Attachment 13

Documents forwarded to the EPA by ResourceCo

ResourceCo's Response to NSW EPA's 11 July 2016 Energy from Waste Questions regarding ResourceCo's Resource Recovery Facility Wetherill Park SSD 7256

Appendix A1 TITECH autosort 4 – RDF online analysis

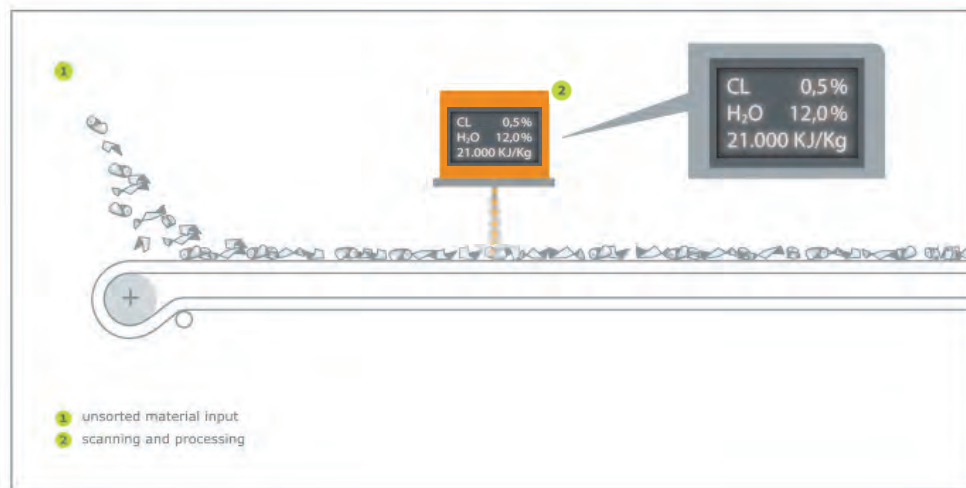
EPA comments on RtS: Limited information is provided to outline controls and management for the removal of halogenated substances. A specification for a cement kiln is provided, however there is no information provided to clarify if the proposed facility will only produce material to this specification. Limited QAQC procedures have been provided to demonstrate how the PEF will comply with the proposed fuel specification.

For example, in reference to halogenated substances, the RtS states that: “An online analyser provides real time recording of the Chlorine content of the PEF as well as other parameters. Should fuel going through the analyser be beyond the specification, then this fuel is diverted for re-processing or to landfill disposal.”

- An online PEF analyser for the lower CV PEF output line (the "██████████ PEF") which provides real time feedback on the major parameters of chlorine content, calorific value and moisture. Again please refer to Appendix 4 for further details on how this QC process will work. It is important to note that this online analyser does not replace the physical testing regime – it is there to provide proactive real time feedback on key elements to enable continual refinement of the process to ensure the key parameters remain within specification. The chosen analyser and its detail is attached in Appendix 6. The calibration procedure to ensure this analyser remains within specification will be finalised with the manufacturer during the installation and commissioning of the machine. The analyser is also only placed on the "██████████ PEF" line as this product has a lower chlorine content specification and the analyser will help ensure this line continually produces within the 0.2% Cl specification. An analyser is not required on the other PEF line (the "Lafarge Holcim Kanthan" higher CV line) as this material has the more usual 0.8% Cl specification, and in ResourceCo's experience with multiple PEF plants over time combined with the fact that this line will be processing naturally PVC/chlorine free light two dimensional plastic inputs, the chlorine content will be well within the 0.8% Cl specification. It is important to note that all the Lafarge Holcim Kanthan PEF from the Wetherill Park facility is unloaded and debaled at the ResourceCo Asia facility in Ipoh and blended with locally made PEF to ensure Lafarge Holcim Kanthan is supplied with a consistent PEF material

DRAWING TITLE
STAGE 1
EROSION & SEDIMENT
CONTROL PLAN
DRAWING No
TX-11972.00 C01 ISSUE 0

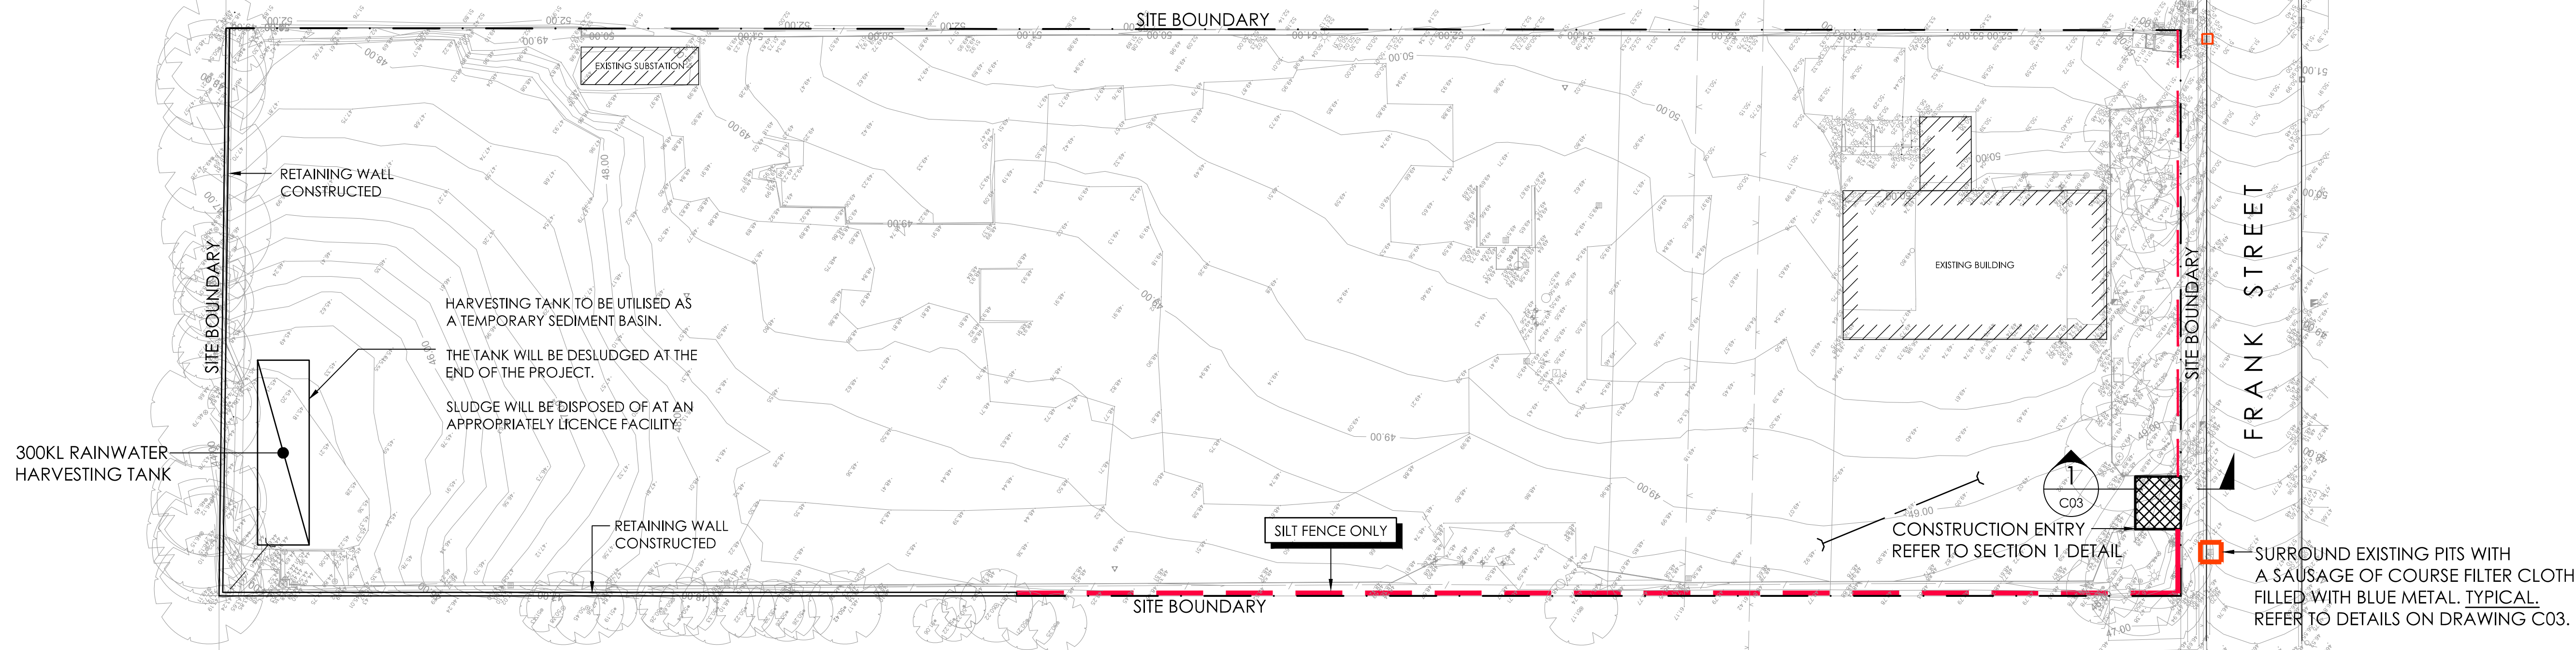
Response to EPA item – Discharges during construction

The proposed stormwater and sediment management measures during construction are shown in Triaxial Consulting drawing numbers C01, C02 & C03, Appendix A. Likely pollution caused by carrying out the construction work will be sediments from soil and other building materials. Most of the sediment pollution would be from erosion during a storm event. The stormwater and sediment management measures shown in the Triaxial erosion & sediment control plans & details reduce and control this form of pollution to protect the downstream environment. The significant changes from the Mott McDonald sediment management plan are:

- The existing sediment basin is not going to be used as the existing basin is partly under the proposed building footprint so the previous method would not have been able to be used for the full construction phase.
- The sediment control will now be a two stage process during construction as shown in the sediment control plans for stage 1 & 2 to ensure that there is adequate control at all stages of construction.
- The proposed stormwater harvesting tank will be used for sediment control as part of stage 2. This will ensure there is sediment control even when the last sections of external pavement are being constructed. The waste from this will be removed off-site.

- The water treatment requirements for any discharge from the sediment basin/tank are documented on the revised Triaxial Consulting Erosion & Sediment Control Plans. These measures will control any polluted water and prevent polluted discharge to the waterway which flows to Prospect creek.
